Kiel High School

Swimming Pool Audit

July 17, 2013

Image 21: Rollout Perimeter Overflow Gutter along the Length of the Pool

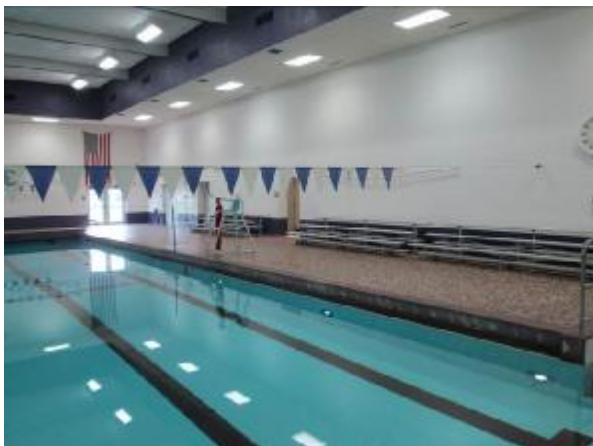
- a) An open-faced concrete and tile rollout gutter is provided along the two lengths of the pool and the shallow end wall. A full concrete and tile parapet (12" high and 18" wide) is provided at the deep end of the pool. This perimeter overflow gutter serves as the means for recirculating the pool water at the surface back to the filtration system. No grating is provided over the gutter.

- c) The gutter trough itself is only a few inches deep and has minimal capacity. While it can handle the quiescent recirculation conditions, when competitions are held in the pool, the gutters likely return a lot of wave rebound from swimmers' wake into the pool creating choppy conditions and therefore a "slower" pool.

Image 22: Metallic Gutter Dropout and Handhold Corrosion

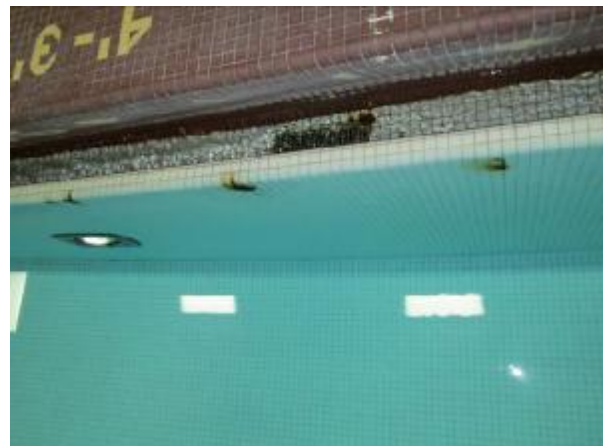
- d) As noted previously, there was some corrosion evident around the gutter handhold in a few areas.
- e) The dropouts were metallic and showed signs of corrosion.

- a) The areas where corrosion was observed in the pool tank should be thoroughly remediated by removing the finish, routing out around the corroded areas, epoxy injected, and refinished.

Image 25: Pool Main Drain Cover

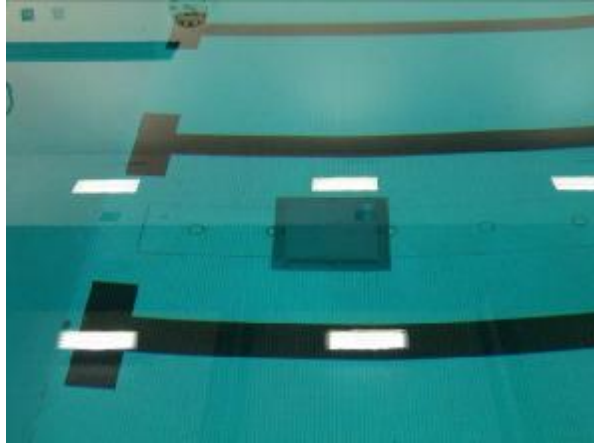
- a) One large main drain cover was installed over the main drain sump. It appeared to be an Aegis drain cover, supplied by Neptune-Benson. The Aegis cover is Virginia Graeme Baker approved for flow rates up to 600 GPM at a velocity up to 1.5 ft/sec.

- a) Based on the competition pool flow rate of 450 GPM, the suction outlet is properly designed per the federal Virginia Graeme Baker Act. However, because there is only a single suction outlet, a vacuum release device (SVRS) should be installed on the suction side of the pool pump. And per VGBA, the suction cover is required to be replaced at the end of its useful life as stated by the manufacturer (typically 7 to 15 years). This information should be on the cover of the drain grates, so the owner should confirm the next time the pool is drained for maintenance.

Image 45: Inadequate Depth Profile at Diving Board Plummet

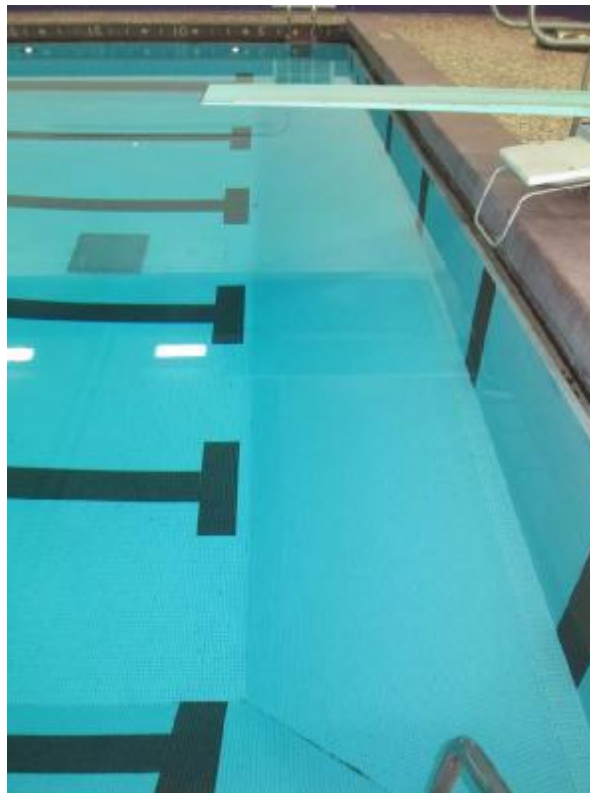
- b) There was some delamination on the springboard itself and the stand as well as some corrosion.
- c) Current National Federation of State High School Associations (NFSHSA) regulations require a minimum plummet depth of 12'-0" for 1 meter diving and the State of Wisconsin requires a minimum depth of 11'-0". The dimensions from the centerline of the diving board to the slope break and to the side wall also fall short of both of these minimum standards. Often these can be considered for grandfathered situations with local health departments, but not always. Also, there is typically a significant insurance premium that these older facilities have to pay to their providers if they don't meet current local and industry standards. It is what has led to many facility's determining that the best path forward is to simply remove the diving board(s).

- a) Inquire with local health department official if a grandfathered exemption is possible to the current envelope profiles for the State of Wisconsin and the NFSHSA standard.
- b) Determine if there are premium penalties assessed by the insurance provider and if it is preferred to continue diving or eliminate the board.
- c) If diving will be continued in light of the first two items, consider if the diving board should be moved towards the middle of the pool to help mitigate some of the lateral clearance issues to the side wall. Doing so would require a new diving pedestal and the diving board will need to be bonded. Any relocation will need to be verified with a structural engineer and the loads anticipated on the deck.
- d) Replace the diving board and stand within 5 years as delamination and corrosion worsens.

Image 50: Patina at Starting Block Anchors

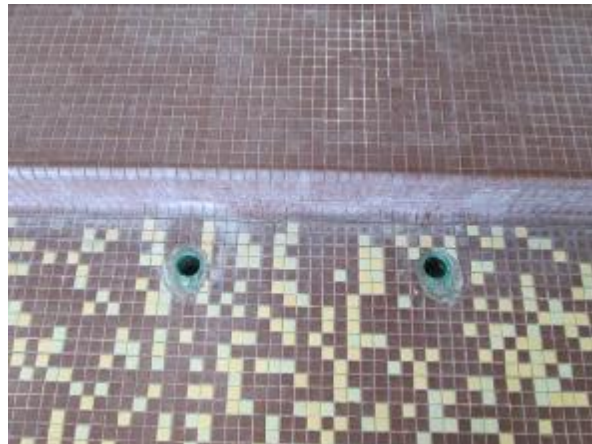
- a) The starting blocks for the competition pool were stainless steel and dual post. Only one block was installed and observed during the inspection. This block appeared to have a custom and permanent installation due to the location of the diving board.
- b) Some mild corrosion was observed on the stainless steel posts of the starting blocks.
- c) The starting block observed was installed 29" above water level which meets NFSHSA regulations.
- d) Similar to the other deck anchors there was a green patina observed at the anchor sockets.
- e) There were anchors at the shallow end of the pool, but no starting blocks were installed. There was also conduit assumed to be for a timing system at this end of the pool coming through the concrete in the tunnel. The minimum water depth under starting blocks per NFSHSA is 4'-0".

- a) All stainless steel in the natatorium above the waterline, including the starting blocks, should be a part of regular maintenance. They should be wiped down regularly with approved stainless steel cleaner such as SpectraClean provided by Spectrum Products. More established, set-in corrosion will have to be cleaned more aggressively with other means.

Image 62: Motor for Pool Covers

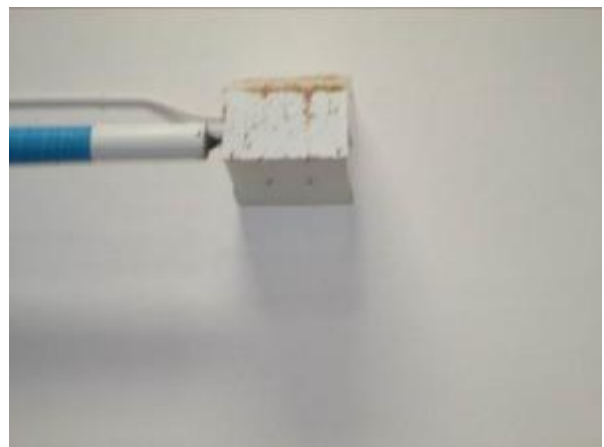
- c) A motorized pool cover is provided for the swimming pool. It was not confirmed whether or not this pool cover is in fact operational. Some corrosion was noted on the motor housing for the automated covers.

- b) The pool cover should be confirmed operational. The pool was closed at the time of the site inspection, so it's assumed that the cover is not utilized as it was intended for energy savings.
